RE: State Significant Development (SSD 5248) Condition C36A – Traffic and Transport Response

Momentum Industrial Estate, Eastern Creek

Concept design road safety audit

ASON-PROJ-0018-01 CD RSA 813-913 WALLGROVE ROAD Rev 5

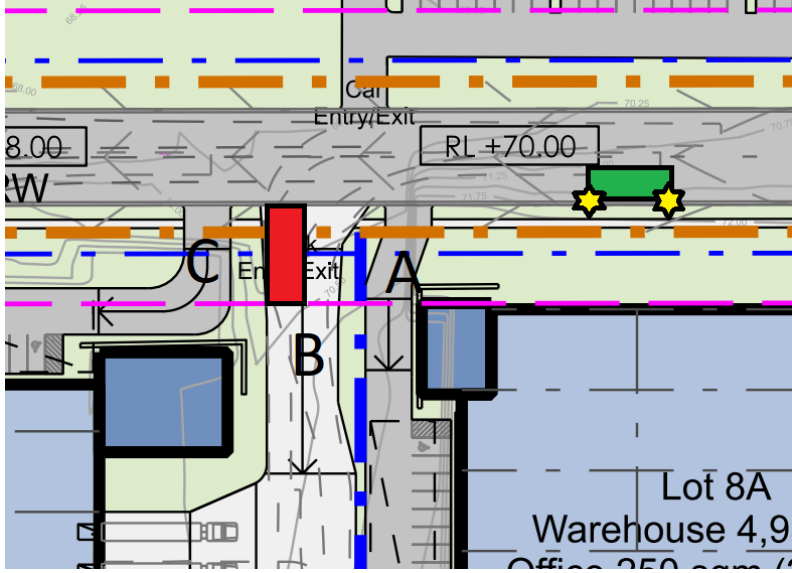
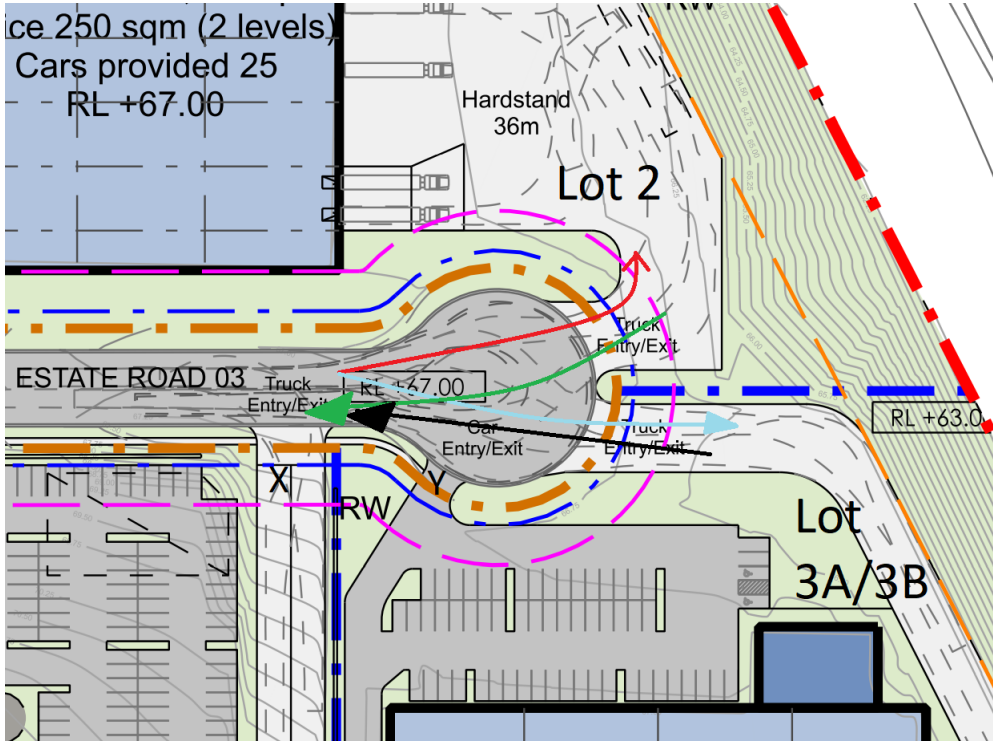
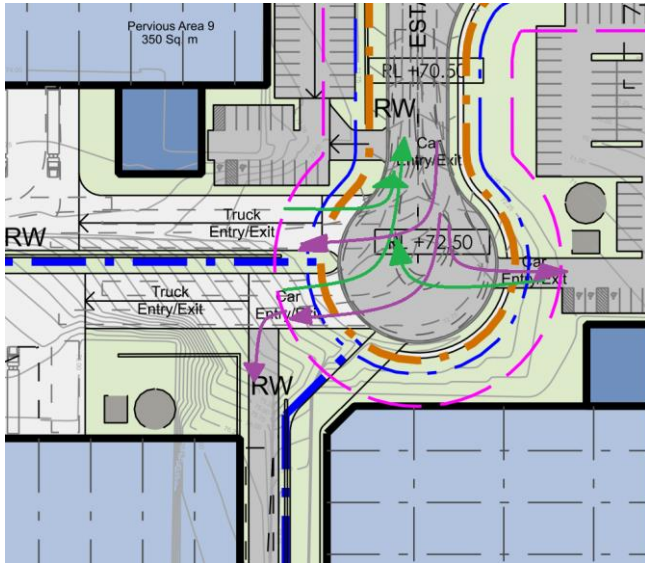
Ref	Location	Road safety audit finding	Risk rating
1	Traffic generation impacts and potential delays and queuing.	Delays and queuing are performance indicators of traffic management. However, they also have implications on road safety such as (i) frequent queuing and flow-breakdown which gives rise to <i>rear-end</i> crashes, (ii) increased delays which may result in increased driver frustration and poor decision making (eg. speeding and red light running), (iii) queues which may spill back to undesirable areas such as blocking outbound and inbound paths at driveways. The audit team envisages that the two areas that will experience the most congestion and queuing would be those coloured in red below. Region 1 would be the outbound traffic from the estate, typically at the end of the work day. The traffic signal operations and limited cycle time allocated to the outbound traffic would reduce the capacity of the intersection to process the outbound traffic. This is especially the case for outbound right-turning movements as these would have more conflicting traffic movements and hence less opportunities/ phases to complete the movement in. The design also indicates that a single outbound lane would be provided in Access Road and hence the right-turning vehicles would be mixed with left-turning vehicles without any opportunity to optimise the discharge of these two traffic streams (ie. via dedicated signal phasing). For example, if a left-arrow hold is displayed to protect pedestrians on the northern crossing, and a left-turning vehicle is at the head of queue, then this held vehicle will penalise all right-turning vehicles queued behind, which are not held on red arrow. There will be a lot of wasted green periods due to the mixed traffic. The total quantum of traffic generation would be based on a total car park supply of 1493 spaces and 71 truck loading docks spread over 16 warehouses which is considered significant. Region 2, on Estate Road 2, would carry the outbound traffic from Lots 1, 2, 3A, 3B, 4, 5 and 6. This traffic would be generated from a supply of 490 car parking spaces and seven warehouses. Furthermore, this traffic would be attempting to enter Estate Road 1 which needs to cater to a traffic generation based on a supply of 561 car parking spaces and six warehouses. As Estate Road 2 is a lower priority than Estate Road 1, the high degree of conflicting traffic, and the lack of gaps in Estate Road 1 will result in considerable queuing in Region 2. A significant traffic management risk is the extremely high dependence on the single point of access-egress via the Wallgrove Road intersection. Any breakdown in traffic movements at that location and beyond, could result in large-scale queuing and congestion in Access Road and its connecting routes.  Left: The audit team envisages that there will be large-scale queuing and congestion in the two regions shaded in red.	Medium (Probable + Limited)

Ref	Location	Road safety audit finding	Risk rating
2	Estate Road 1 between its intersections with Lot 13A and Estate Road 2.	The audit team considers that there are too many access points in close succession and hence a clustering of turning conflicts associated with these access points. In this section of Estate Road 1, there are the following accesses and side road turning movements: ▪ Driveway to Lot 13A car park (WH13): This car park will allow inbound left turn movements, outbound left-turn movements (numbered 5 in image below), inbound right-turn movements and outbound right-turn movements (6). ▪ Truck exit from Lots 13A and 13B: This will allow outbound left-turn movements (4) and outbound right-turn movements (3). ▪ Driveway to Lot 14 car park (WH14): This car park will allow inbound left turn movements, outbound left-turn movements (8), inbound right-turn movements and outbound right-turn movements (7). ▪ Driveway to Lot 13B car park: This car park will allow inbound left turn movements, outbound left-turn movements (2), inbound right-turn movements and outbound right-turn movements (1). ▪ Estate Road 2: This will allow inbound left turn movements, outbound left-turn movements, inbound right-turn movements and outbound right-turn movements. These are not depicted below due to the information clutter. This presents a high volume of conflicting vehicular movements and complex gap-checking and acceptance by outbound drivers. As such, the audit team anticipates a significant risk of crashes. This includes frequent near-miss events where conflicting vehicles converge without incident but where one driver/ vehicle needs to make space for the other to pass first. Item 3b discusses typical scenarios where crash risk would be increased as a result of close spacing of successive driveways and access points. Although those scenarios are associated with another site, they are also applicable and relevant to this location. The project team should consider traffic management methods to reduce and rationalise the conflicts and to present a more orderly traffic management arrangement.  Left: The close spacing of successive driveways and access points would give rise to a multitude of turning movements and conflicts. This presents an untidy arrangement from a traffic management perspective.	Medium (Occasional + Minor)

Ref	Location	Road safety audit finding	Risk rating
3a	General – More discussion on the impacts of closely spaced intersections and access points.	Item 2 discussed issues associated with the closely spaced accesses and intersections along Estate Road 1 between the Lot 13A car park access and Estate Road 2. Further to that discussion, the audit team raises the issue of closely spaced driveways in general. This is because there are also closely spaced driveways and access points along Estate Road 2, Estate Road 1 in the western portion of the site and the cul-de-sac terminals at the ends of each of these roads. It should be noted that regardless of the ultimate lot layouts, and hence driveway positions, the number of warehouses and the lot sizes are fixed. This means that regardless of where driveways are positioned, there are likely to be closely spaced access points. Hence, it is the higher-level message that should be considered. The left-hand image shows a series of access points along the western portion of Estate Road 1. These include (from east to west): (i) The inbound access to Lot 7 car park, (ii) the truck entry point to Lots 13A and 13B, (iii) the truck exit point from Lots 11 and 12, (iv) the truck access and egress to Lot 7, (v) The truck access and egress to Lots 8A and 8B, (vi) the car park access/egress to Lot 11 and 12, (vii) a second car park access/egress to Lot 11 and 12, (ix) an inbound access to the car park to Lots 8A and 8B, (x) The truck entry and egress to Lot 9, (xi) the inbound access to the car park of Lot 9, (xii) the inbound truck access to Lots 11 and 12, (xiii) The truck egress from Lot 10, and (xiv) the combined truck and car entry to Lot 10. This is also a case of there being too many accesses and egresses immediately adjacent to each other. This will present a multitude of turning movements and crash conflicts. It will also make it difficult for drivers to interpret the turning intentions of other vehicles. The right-hand image shows the number of cross-over and merge-related conflicts associated with driveways (ii), (iii), (iv) and (v). In the case of collisions involving similar outbound turning movements from adjacent driveways, this is highly plausible. This is because the outbound drivers are likely to use the same gaps in traffic to perform their outbound turning movement. By doing so, and by being overly fixated on the main line traffic conditions and gaps, they are likely to create collision scenarios due to the coincidental nature of these movements. With these 14 individual access-egress points, a typical traffic management solution is to create “side roads” to collect traffic from adjacent lots and consolidate these into a common point of access-egress. Left: In the short length along the western portion of Estate Road 1, there are a total of 14 access/egress points which creates a multitude of turning movements and conflicts. Right: A micro-analysis of four of these driveways showing the most dominant movements and the multitude of cross over and merging conflicts created. This also assumes that all outbound vehicles turn directly towards the outbound path to Wallgrove Road, and vice versa for the inbound traffic.	Medium (Occasional + Minor)

Ref	Location	Road safety audit finding	Risk rating
3b	General – More discussion on the impacts of closely spaced intersections and access points.	Further to item 3a, the illustration below shows a likely crash scenario that would result from the closely spaced access points and hence the driver's potential confusion in interpreting the intended turning movements of other vehicles. In this scenario, the red vehicle is an outbound vehicle from the loading dock of Lot 9. This driver sees an approaching westbound vehicle (green vehicle) that activates its left-turn indicator light. The driver of the red vehicle would not be certain whether the approaching green vehicle intends to turn left into channel A (Lot 8A and 8B car park), into channel B (the truck entry/egress to the Lot 9 loading docks, or to channel C, the car park for Lot 9. If the red vehicle driver guesses/ assumes/ misinterprets the left turn indicator as an intended left turn into channel A, they may falsely believe that they can safely egress. However, if the left-turn indication was in fact an intended left-turn into channel C, a <i>cross over</i> conflict could be created due to this misinterpretation. This problem would happen at most locations where there are multiple accesses in close succession. This is only one example of driver misinterpretations of intended movements of other vehicles. Many other scenarios would also apply.  Left: An illustrated crash conflict due to closely spaced driveways and the confusion in interpreting the turn signals of approaching vehicles.	Medium (Occasional + Minor)

Ref	Location	Road safety audit finding	Risk rating
3c	General – More discussion on the impacts of closely spaced intersections and access points.	The design extract below shows the closely spaced accesses (inbound and outbound truck accesses) to Lots 2 and 3A/3B. The inbound and outbound movements are superimposed by the red, green, blue and black arrows. As shown, there is a <i>cross over conflict</i> (green versus blue arrows) as well as a <i>merge-related conflict</i> (green versus black arrows). Furthermore, there is also a truck entry and egress to Lot 4 (marked X) and an access to the car park to Lots 3A/3B (marked Y). The green and blue movements may also appear to be travelling on the “wrong side” of each other. That is, these vehicles will pass each other on the right-hand side, rather than the conventional left-hand drive passing practice. More consideration should be given to rationalising and consolidating the conflicts.  Above: The multitude of crash conflicts due to the closely spaced truck entry and egresses at Lots 2 and 3A/3B.	Medium (Occasional + Minor)

Ref	Location	Road safety audit finding	Risk rating
3d	General – More discussion on the impacts of closely spaced intersections and access points.	The left-hand image shows a number of closely spaced accesses. These include: (a) the inbound access to the Lot 5 car park, (b) the truck entry-egress to Lot 5 (which also serves as the outbound driveway for car park traffic, (c) the truck entry-egress to Lot 6 which also links to (d) an access to the car park, and (e) the entry-egress to Lot 4's car park. These are labelled by their letter references accordingly. The inbound and outbound movements are superimposed onto each leg in purple and green arrows respectively. As shown, there is a multitude of crash conflicts caused by the cross over and merging interactions. Moreover, the traffic generation potential is significant with 292 car parking spaces, 36 loading docks and three warehouses accessed off these facilities. In these respects, a more orderly arrangement may be needed.  Left: The multitude of turning movements and conflicts associated with the closely spaced accesses off the cul-de-sac at the eastern end of Estate Road 2.	Medium (Occasional + Minor)

Item no.	Close out responses from the project team
1	▪ Queuing has been designed to occur on the private road and not on the external road network as a requirement of TfNSW. ▪ Queuing within the estate has been modelled as part of the original SSD (see Amended Traffic Report submitted as part of the Response to Submissions Report) indicating that queuing during the AM Peak is around 75m with average delay of around 1 minute. The PM Peak queuing is around 250m with average delay of around 1 minute. This is not considered unreasonable in relation to traffic exiting the estate during the peak periods. ▪ Furthermore, the traffic modelling in the Amended Traffic Report assumed a single outbound lane from the Estate. The design has since evolved and the approved plans of the Wallgrove Road/ Estate access intersection illustrate 2 outbound lanes, one left-turn only and one shared through-right. ▪ This also addresses and closes the Audit's concern regarding "a single outbound lane would be provided in Access Road and hence the right-turning vehicles would be mixed with left-turning vehicles without any opportunity to optimise the discharge of these two traffic streams" and also the concern regarding "wasted green periods due to the mixed traffic" ▪ This level of queuing within the estate road has already been approved under SSD 5248. ▪ The single point access into the estate is considered appropriate as it was a specific requirement of TfNSW and was approved under SSD 5248. ▪ As a private road there is significant scope for Gazcorp to provide guidance and advice to tenants in relation to minimising queuing and managing the associated impacts, if deemed necessary. ▪ In terms of the internal intersection (i.e. at the location left of the area marked 2 in the Audit), low volumes of traffic are expected. As a high-level assessment based on the traffic generation outlined in the approved MOD 1 and the following assumptions: ▪ AM peak: 80% in, 20% out, PM peak: 20% in, 80% out ▪ Traffic generation pro-rated by warehouse + office GFA ▪ Minimal left-turning traffic from Estate Road 02 (east) to Estate Road 01 (north), minimal right-turning traffic from Estate Road 01 (south) to Estate Road 02 (east) - i.e. assume vehicles take the shortest path to their warehouse and internal trips between warehouses are minimal ▪ Analysis indicates that in the: ▪ AM peak: 50 vehicles exiting Estate Road 02 would be opposed by 283 vehicles travelling along Estate Road 01. This is less than 1 vehicle per minute against an opposing flow of around 5 vehicles per minute (or 1 every 12 sec). ▪ PM peak: 111 vehicles exiting Estate Road 02 would be opposed by 146 vehicles travelling along Estate Road 01. This is less than 2 vehicles per minute against an opposing flow of around 2-3 vehicles per minute (or 1 every 20-30 sec) ▪ As such, the opposing flows are minimal and are not expected to generate any notable queuing, particularly along Estate Road 02 as per the Audit's concern. ▪ Therefore, we consider this comment as CLOSED.

Item no.	Close out responses from the project team
2	▪ When reviewing the movements marked in the figure, it should be noted that any movements heading southbound would be minimal, if any. The Estate only has a single connection point to the north, hence it is expected that traffic would be to and from the north. This mitigates much of the conflict illustrated in the figure, reducing complexity in gap-checking and acceptance by outbound drivers. ▪ It is also highlighted that: ▪ Heavy vehicle driveways for Warehouses 13A and 13B are exit only by design. No inbound right turn movements will be allowed. ▪ Driveways for WH13A and 13B are expected to be used practically as left out only. Because there is no through traffic, there is no reason for any vehicles to be turning right out of these driveways, and any right turn movement (whilst not prohibited) would be in practice non-existent or very minimal (i.e. inconsequential). This applies to light vehicles and heavy vehicles. ▪ Similarly, there is not expected to be any reason for vehicles to be turning right from Estate Road 1 (northbound) into Estate Road 2 (or turning left from Estate Rd 2 into Estate Rd 1. ▪ As a private Estate with no through connection to the external road network (aside from the single access point), there is expected to be minimal external traffic and the large majority of traffic accessing the site would be familiar users. As such, these drivers would be familiar with the traffic environment and navigation through the site. To reinforce the above point, signage may be installed at the entrance of the Estate to clearly demarcate the Estate and the nature of the private roads and development. ▪ The proximity of closely spaced intersections at this location is acknowledged. The project team will investigate the relocation of the car driveways WH14 and WH13A further north to provide increased separation to the truck driveway. Detailed design of driveways for WH13A and 14A is subject of future detailed DA process when this issue can be further considered. The WH13B driveway would not be relocated south due to increased conflict that would be introduced by placing it adjacent to the t-intersection and the prohibition of access driveway locations in accordance with Fig 3.1 of AS2890.1:2004. ▪ As a private road there is also significant scope for Gazcorp to implement traffic management measures to minimise traffic conflicts and crash risks if they arise. Measures that could be implemented include signage, boom gates, signals etc ▪ Therefore, we consider this comment as CLOSED.

3a	▪ The truck driveway for WH11/12 is exit only and the truck driveway for WH13B is entry only. Therefore, instead of the multiple red and green arrows, there should only be a single red arrow outbound and a single green arrow inbound. This is a simple arrangement with priorities clearly established by standard road rules in that vehicles exiting the WH11/12 driveway would need to give way to vehicles within the road, including vehicles entering the WH13B. ▪ Similarly for the other driveways in this part of the estate. 4 driveways located close to each other – 2 on each side of the road, is not an uncommon arrangement for industrial estates. Priorities would be clearly established by standard road rules in that vehicles exiting would need to give way to vehicles within the road. ▪ The RSA notes 14 individual access/egress points. However, this is spread over a 300m section of internal road and is not dissimilar in driveway density to standard industrial estates. For consideration is that there would be minimal, if any, through traffic in the Estate due to the enclosed nature and single access point to the external road network. The low traffic volumes would result in low incidence of concurrent vehicle movements. ▪ As a private Estate with no through connection to the external road network (aside from the single access point), there is expected to be minimal external traffic and the large majority of traffic accessing the site would be familiar users. As such, these drivers would be familiar with the traffic environment and navigation through the site. To reinforce the above point, signage may be installed at the entrance of the Estate to clearly demarcate the Estate and the nature of the private roads and development. ▪ As a private road there is also significant scope for Gazcorp to implement traffic management measures to minimise traffic conflicts and crash risks if they arise. Measures that could be implemented include signage, boom gates, signals etc ▪ Driveway locations and design can still be further refined as each individual warehouse will need to undergo a DA process. ▪ Therefore, we consider this comment as CLOSED.

Item no.	Close out responses from the project team
3b	▪ This design outcome is common practice and present across a range of locations including existing industrial estates. Per the road rules, vehicles entering the roadway (e.g. from a driveway) need to give way to all other vehicles on the roadway. In practice the red vehicle illustrated would give way to the green vehicle until the green vehicle has commenced their turning manoeuvre or has passed the red vehicle. ▪ As a private Estate with no through connection to the external road network (aside from the single access point), there is expected to be minimal external traffic and the large majority of traffic accessing the site would be familiar users. As such, these drivers would be familiar with the traffic environment and navigation through the site. To reinforce the above point, signage may be installed at the entrance of the Estate to clearly demarcate the Estate and the nature of the private roads and development. ▪ As a private road there is also significant scope for Gazcorp to implement traffic management measures to minimise traffic conflicts and crash risks if they arise. Measures that could be implemented include signage, boom gates, signals etc ▪ As mentioned in 3a, driveway locations and design can still be further refined as each individual warehouse will need to undergo a DA process, and the feasibility of shifting the location of the driveway marked "C" westwards can be investigated with the subsequent DA for Lot 9. ▪ Therefore, we consider this comment as CLOSED.

3c	▪ There are only 3 driveways at this cul-de-sac and this is not an uncommon arrangement in industrial estates. This design accommodates the required space for large truck manoeuvres and assists in minimising the width of access driveways. As mentioned in 3b, the NSW road rules clearly articulate the requirement for vehicles entering the roadway to give way to all other vehicles on the roadway, hence a clear priority is established. ▪ To further delineate the movements, a painted central island can be considered in the cul-de-sac to minimise the directness of the movements (shown in green and light blue in the Audit). Detailed design for the warehouse driveways can also be further investigated in the individual warehouse DAs to refine the design. ▪ Therefore, we consider this comment as CLOSED.
3d	▪ As above. Therefore, we consider this comment as CLOSED.
4	▪ This is unlikely to be an issue due to the nature of the development. The Estate and the Estate Roads are private and there would be limited, if any, external through traffic in the Estate. ▪ Sufficiency of parking provisions within each lot, in line with the consent requirements, ensures parking demand is captured off-street. ▪ Signage and line marking can be implemented to reinforce areas prohibited for on-street parking. This can consider factors such as sight lines, proximity to driveways and manoeuvring space. ▪ As above. Therefore, we consider this comment as CLOSED.
